# PlanGrid Task Report - Feb 18, 2025

Prepared by Dale Wheeler

**01041 South Parkway FSU // Huntsville, AL ...**

IMG\_7083

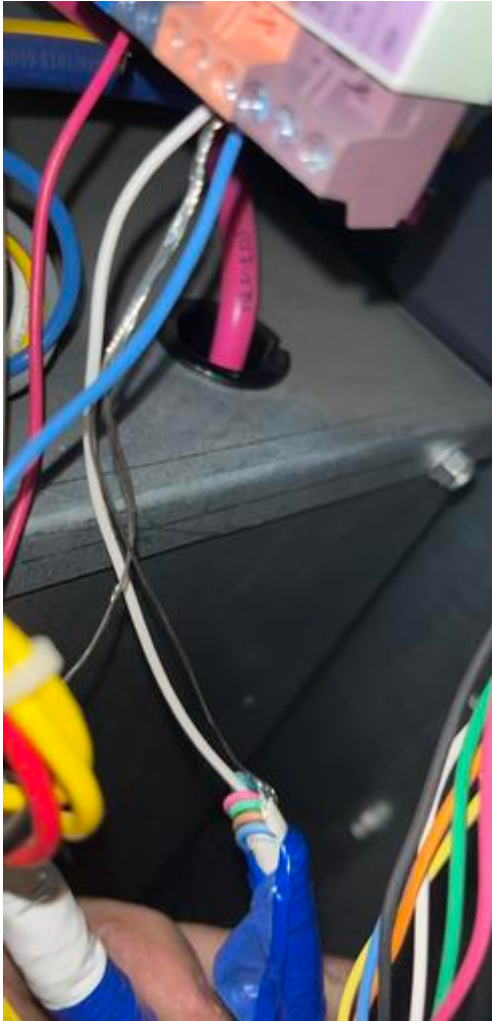
AC1, AC2, AC3, AC4  
humidity sensor wiring used  
is incorrect per plans:  
SHIELDED CABLE BY MC.  
NETWORK THERMOSTAT  
CONNECT-AIR  
W1812C-2148,  
HONEYWELL GENESIS  
TWP-18/12 (47690112) OR  
EQUAL . 18AWG, 1-PAIR,  
TWISTED,  
SHIELDED, WITH DRAIN.  
PLENUM RATED. NO  
SUBSTITUTIONS.
